Sandia National Laboratories

August 29, 1984

Subject: Review and Evaluation of the Indian Point 2 Reactor
Vessel UT Indication

Figure 1. Refractive Beam Widths as a Function of a Flat Surface or a Curved Surface.

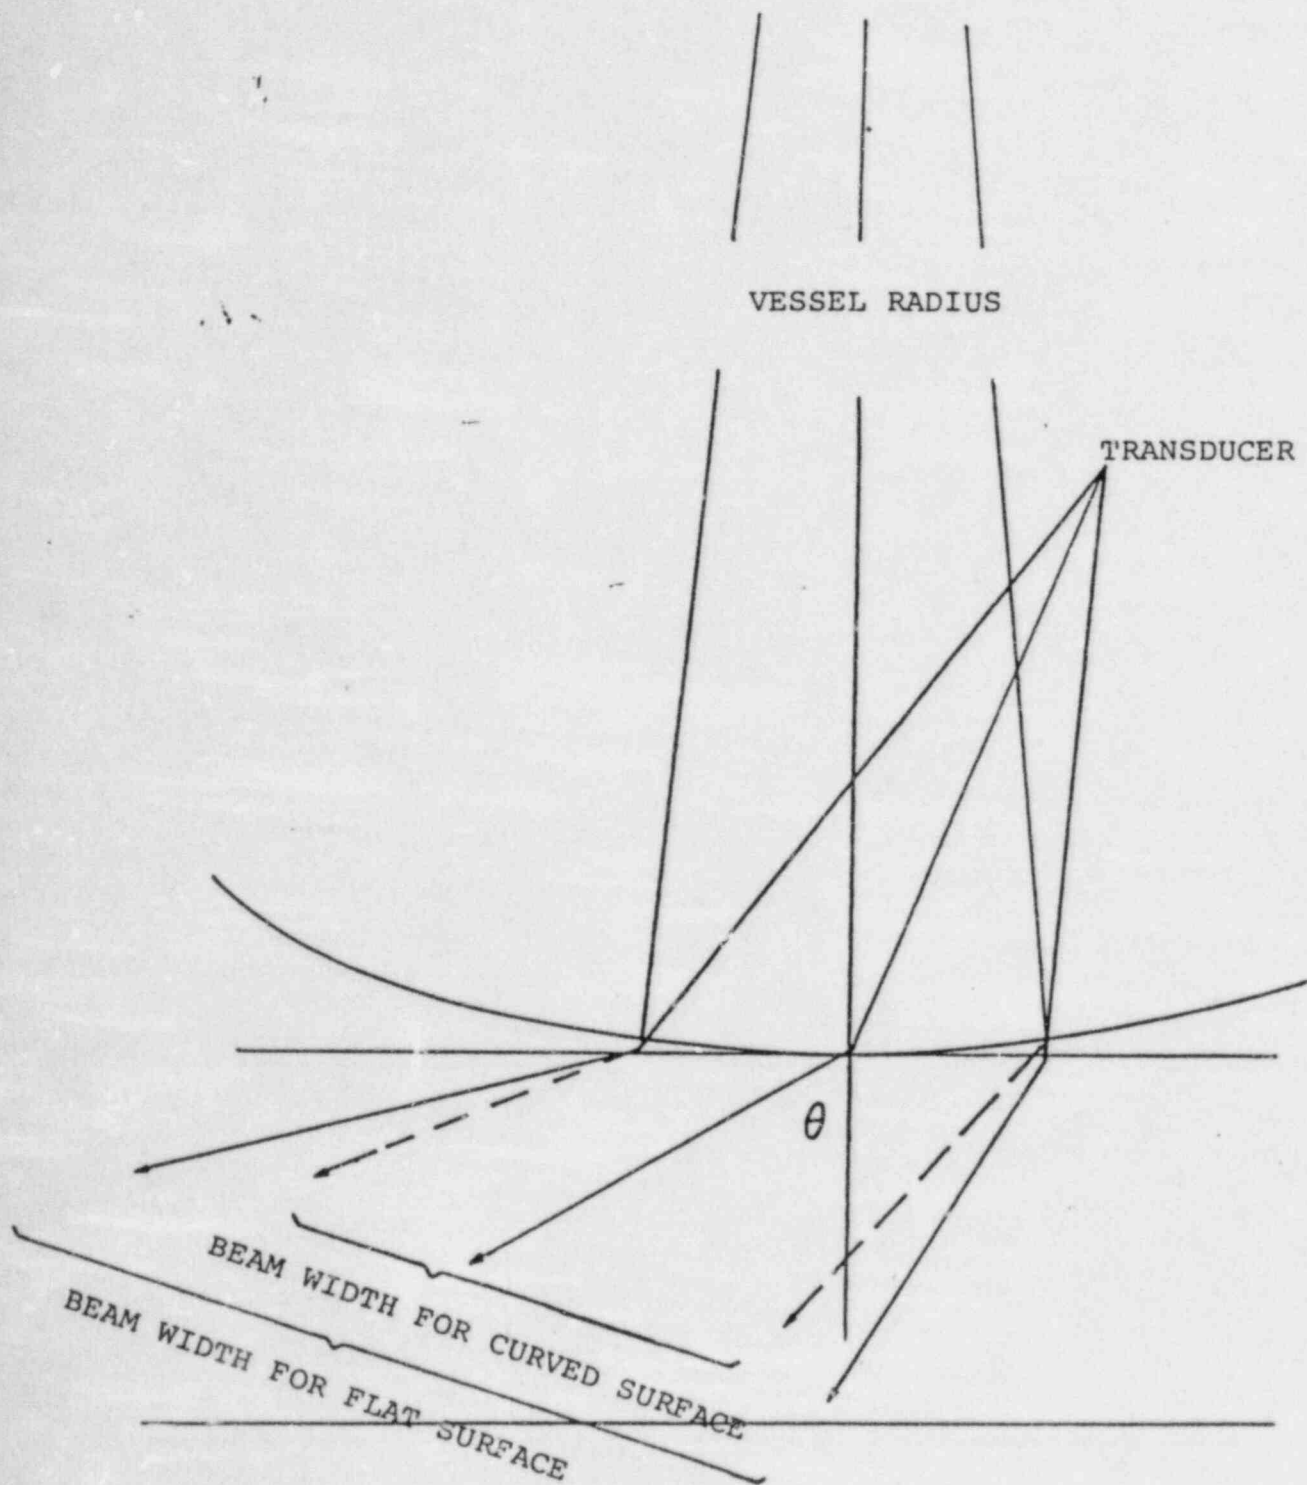
The increased signal is thought to be partly due to the converging lens effect of the ID curvature of the mockup on the broad immersion beam. Figure 1 illustrates the difference in the refracted beam widths due to a flat and curved surface. The measured beam widths given above, however, are in very good agreement which indicates that some other reason for the 30 dB increase in signal is responsible.

FIGURE 2. CRACK THROUGH WALL DEPTH VERSUS TIME INTERVAL RESULTING FROM A TIP DIFFRACTED L-WAVE AT 0 DEGREES FOR INCIDENT S-WAVES AT 45 AND 43.7 DEGREES.

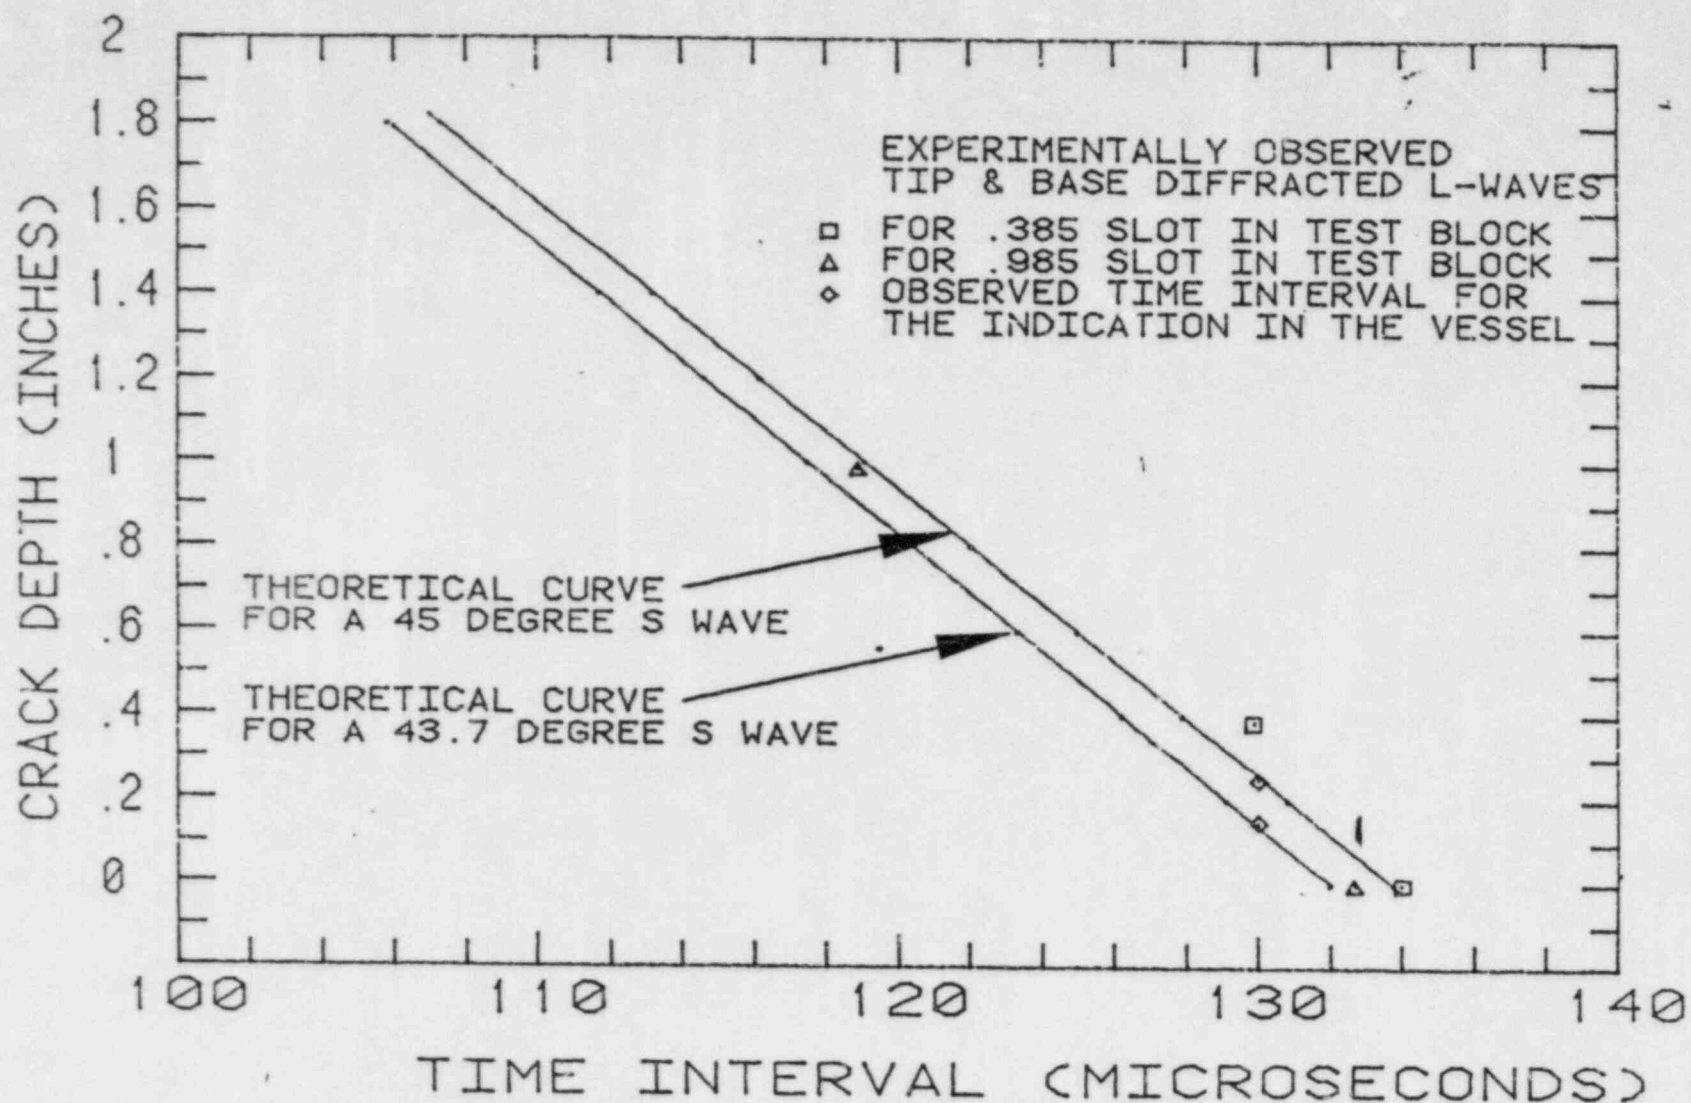
The time interval can be measured to within 0.1 microsecond so that depth information can be potentially determined to within 0.01 inch. Knowing the exact geometry of beam angle, vessel thickness, and determining the water path delay accurately, may be the greatest sources of error. The demonstration was set up in a hurry and some of these factors may have influenced the time interval measurements of the slots. The main purpose of the demonstration was to experimentally show NRC and consultants that the tip diffracted L-wave was present and could be used to make depth measurements of the crack indication in the vessel. Even so, the determined slot depths by this technique for the demonstration were in good agreement with actual values as shown in Figure 2.

Assuming that an ideal geometry is known for the vessel indication, the crack depth for the observed shortest time interval measurement of 130.0 microseconds is 0.14 inches for a 43.7 degree S-wave and 0.26 inches for a 45 degree S-wave. Therefore, the 0.3 inch depth evaluation by Westinghouse is valid.

Figure 3. Geometry of the Delta and Pitch -Catch Techniques.

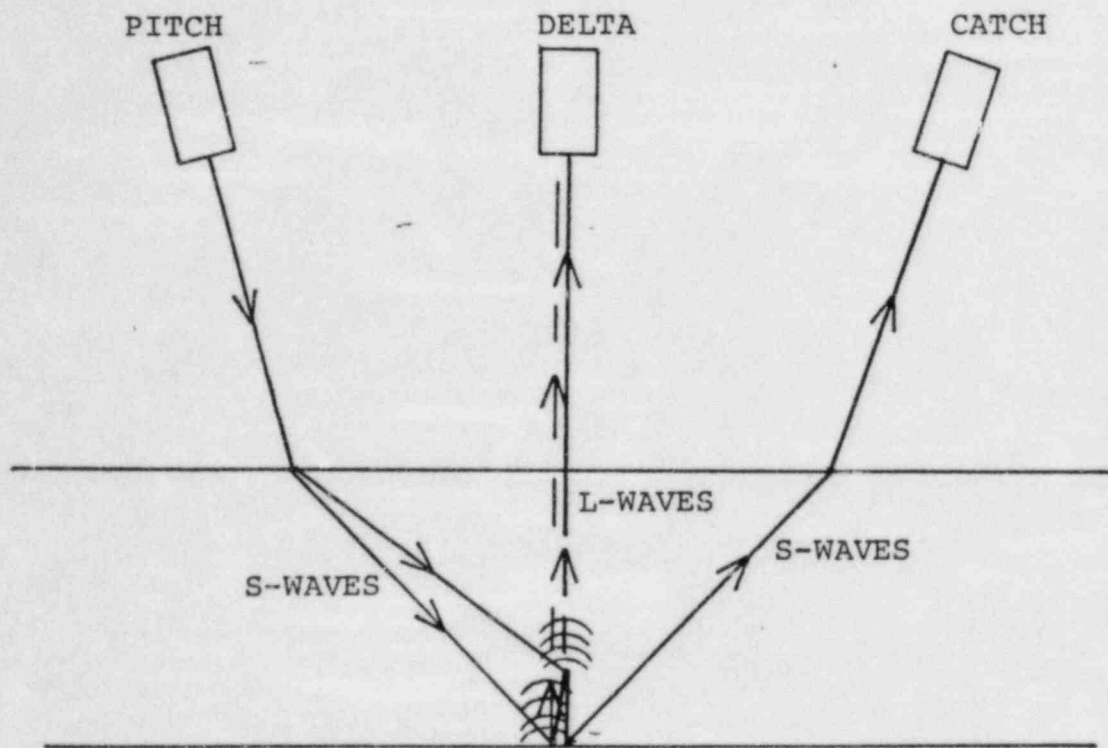
The third demonstration performed by Westinghouse showed the amplitude shadowing responses of the slots in the pitch-catch mode

of operation which is also illustrated in Figure 3. This demonstration verified that a significant reduction of the received signal was observed (100% to 15%) as the beam traversed the 0.985 depth slot and only a slight reduction was observed as the 0.385 depth slot was scanned. However, shadowing of the signal during the vessel examination was inconclusive since similar amplitude reductions were observed in locations away from the crack indication and exact positions of the pitch-catch transducers with respect to the crack indication could not be determined from the video tape data. For this demonstration, the 2S time interval measurement was 188.9 microseconds which is in good agreement with the theoretical values of 188.2 for a 9.0 inch thickness and a 43.7 degree angle beam. The theoretical value for a 45 degree angle beam is 191.8 microseconds.
